STAFF RECOMMENDATION

911 Lawrence Avenue

December 16, 2020

Application: New Construction—Addition

EXTERIOR
ELEVATIONS

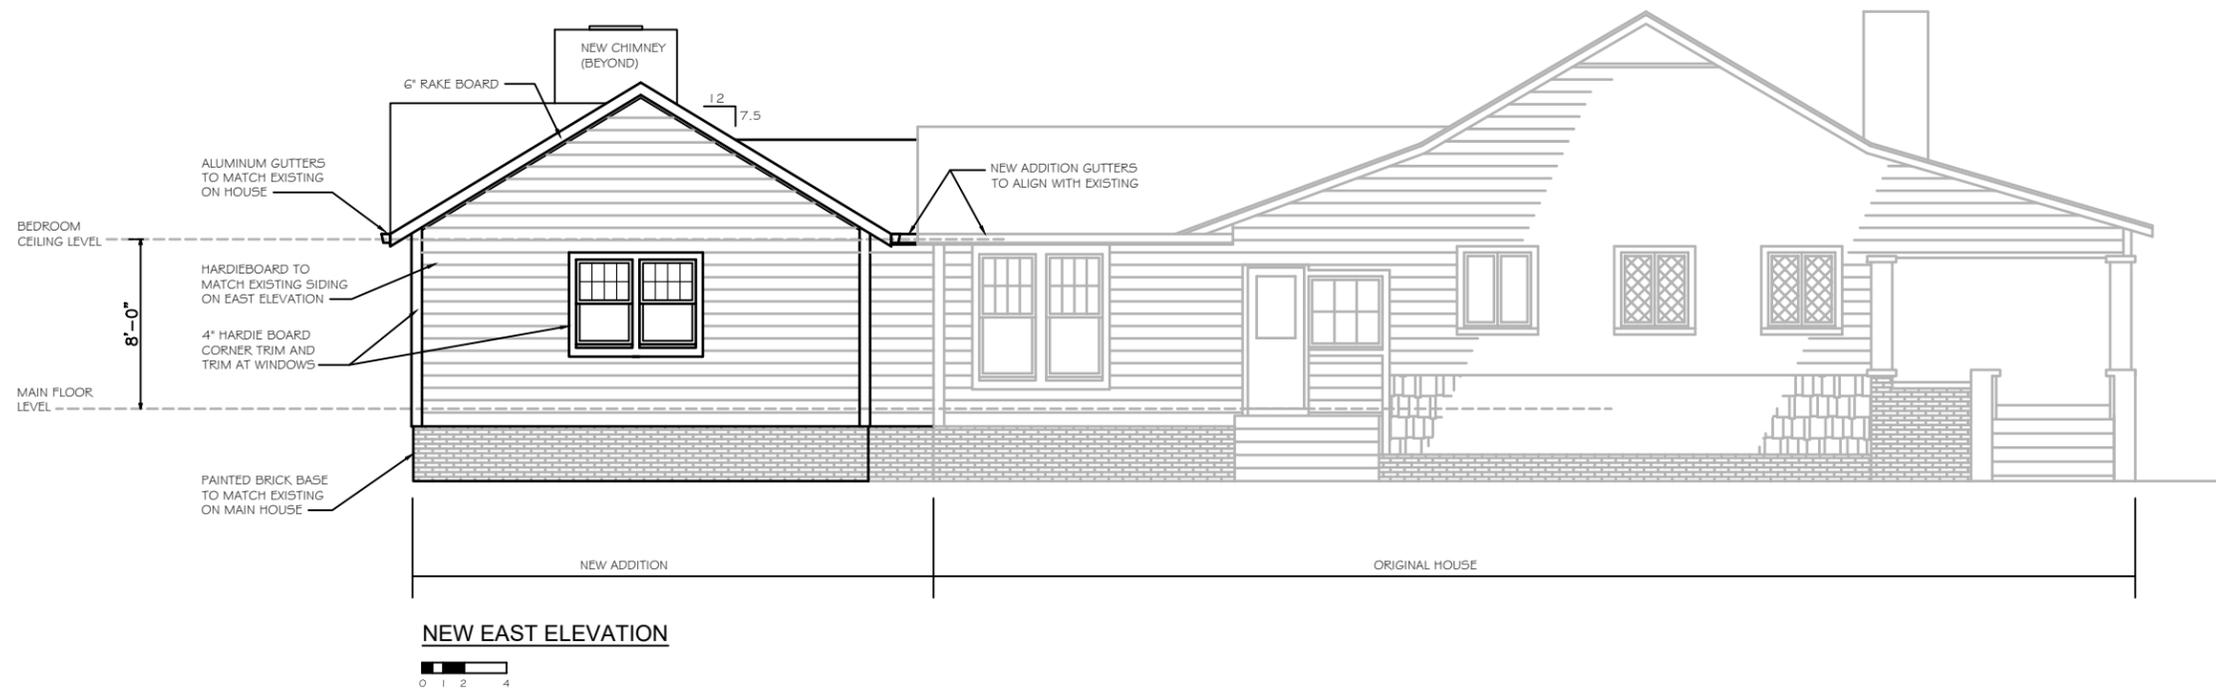
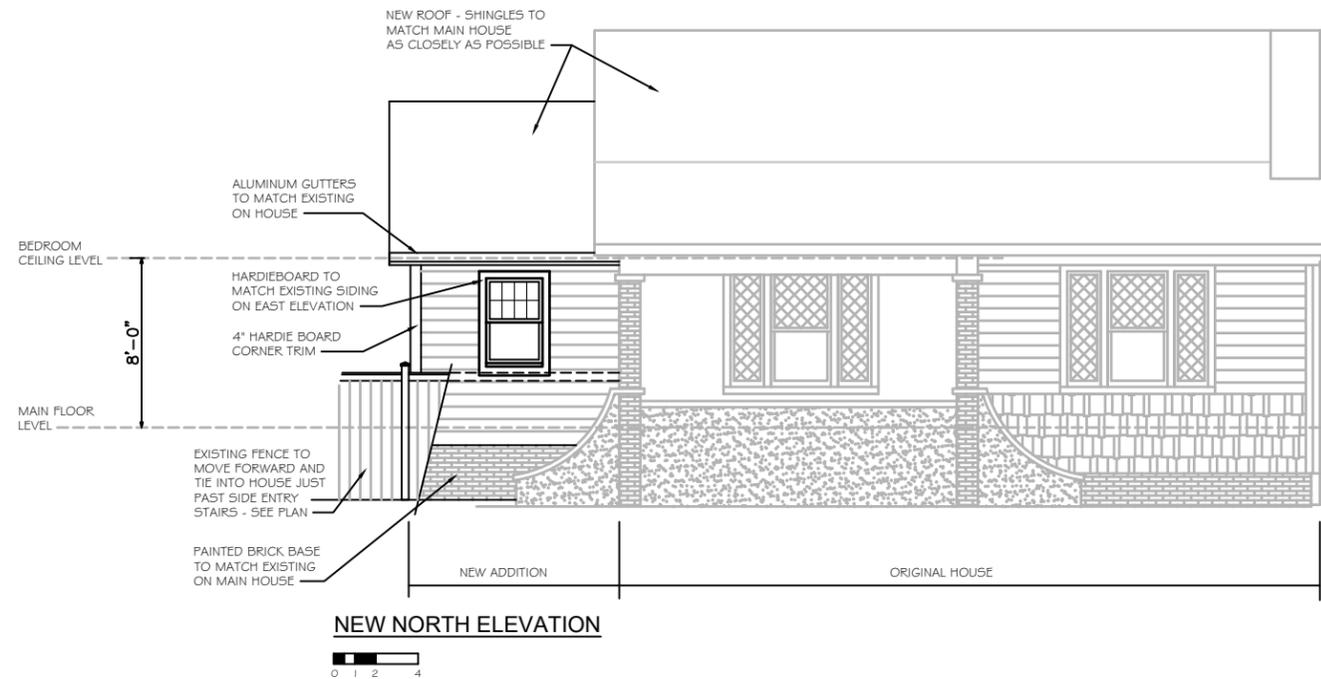
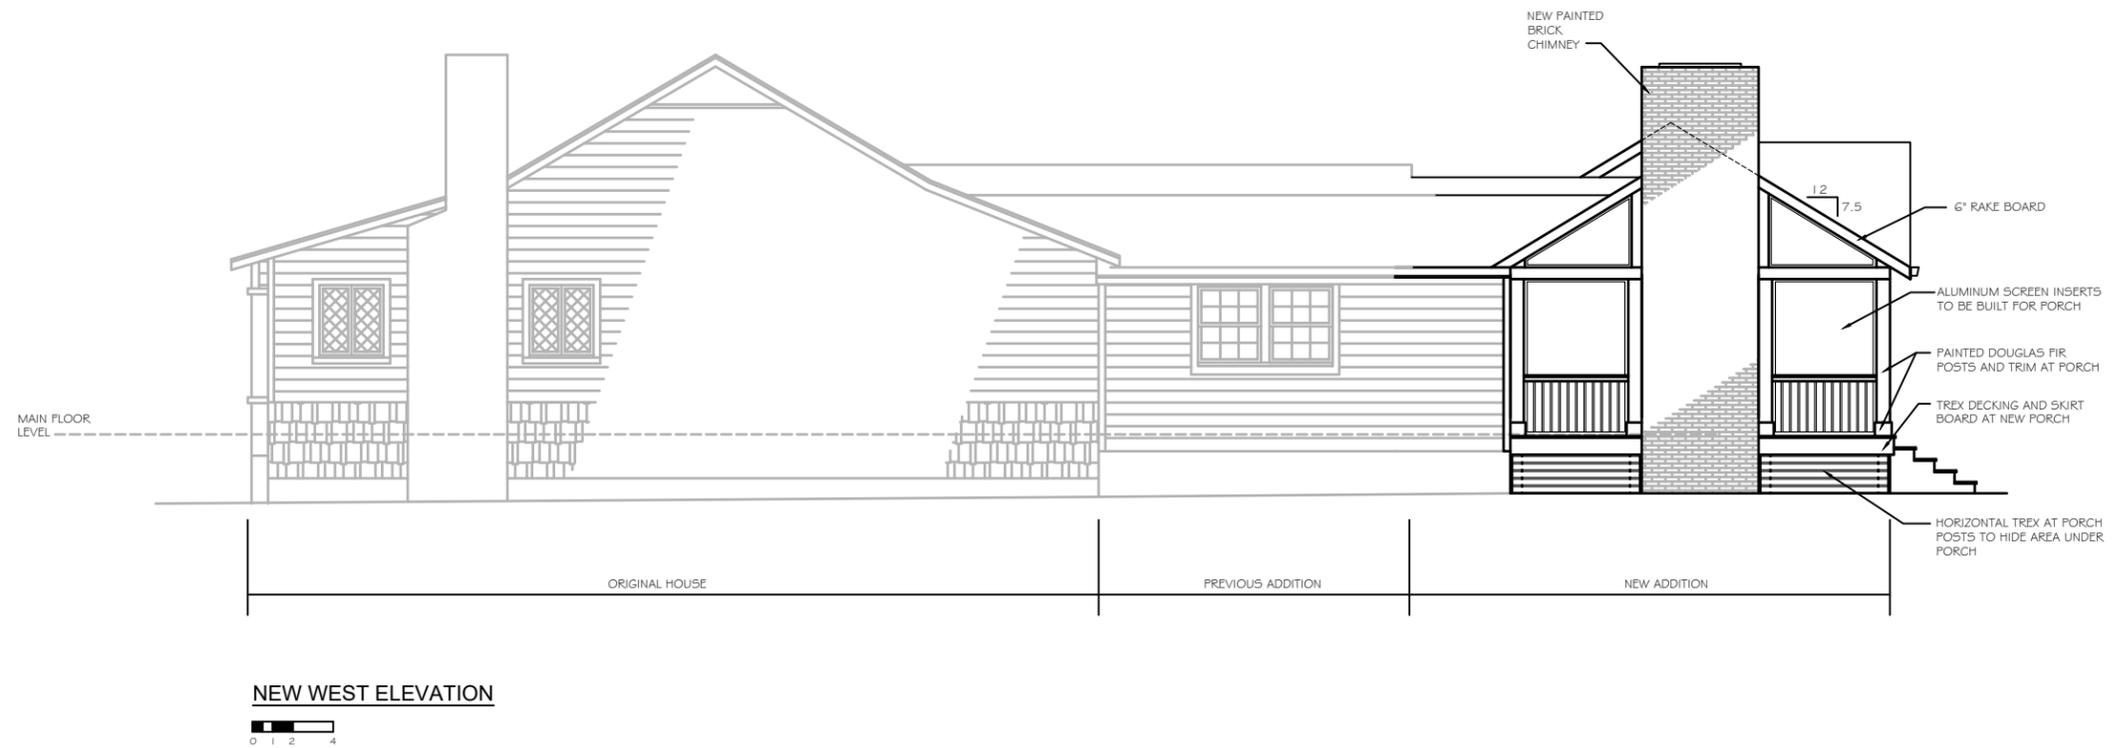
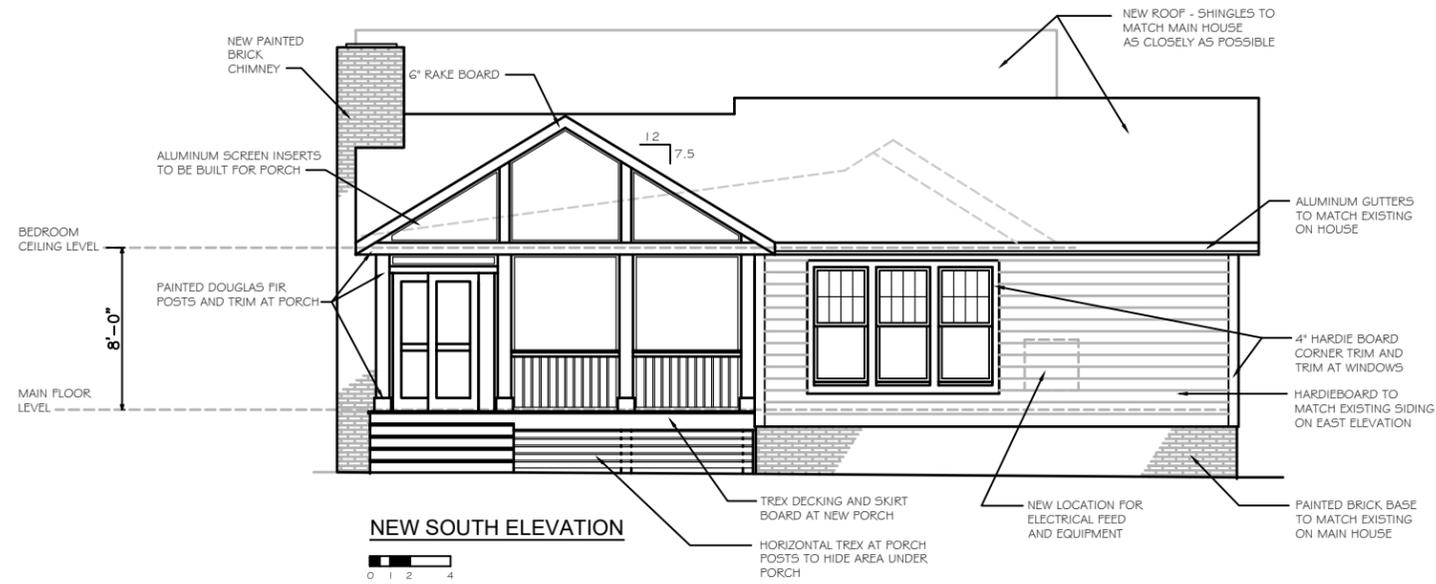
Design: The character of the addition is compatible to the historic house in its detailing, with a similar roof shape and eave profile, vertically oriented, divided-light windows, and matching exterior materials. The form of the addition will be distinguished from the original building by stepping in from the left side walls before continuing back and then stepping wider.

Height & Scale: The addition ties into the rear slope of the roof at the same location as the previous addition, more than five feet (5') below the side-gabled ridge. The wider component of the proposed addition will have a side-gabled ridge as well, three feet (3') lower than the original roof ridge. The eaves and foundation height of the new addition will match the corresponding heights on the historic house.

Roof form: The addition will have a side-gabled roof on its primary component, with a perpendicular ridge connecting it to the existing side-gabled roof. The new roofs will have a 7.5/12 pitch, which will not contrast with the 7/12 pitch of the original roof.

Proportion and Rhythm of Openings: The windows on the addition are all generally twice as tall as they are wide, with no large expanses of wall space without a window or door opening.

Staff finds that the character of the addition does not contrast with the historic house, therefore it will meet Section IV.B, IV.C, IV.F, and IV.G of the design guidelines.

Staff finds the roofs of the proposed addition will be compatible with the historic house, and that the project meets sections III.E and IV.C of the design guidelines.

Staff finds the project's proportion and rhythm of openings to meet Section III.G. of the guidelines.
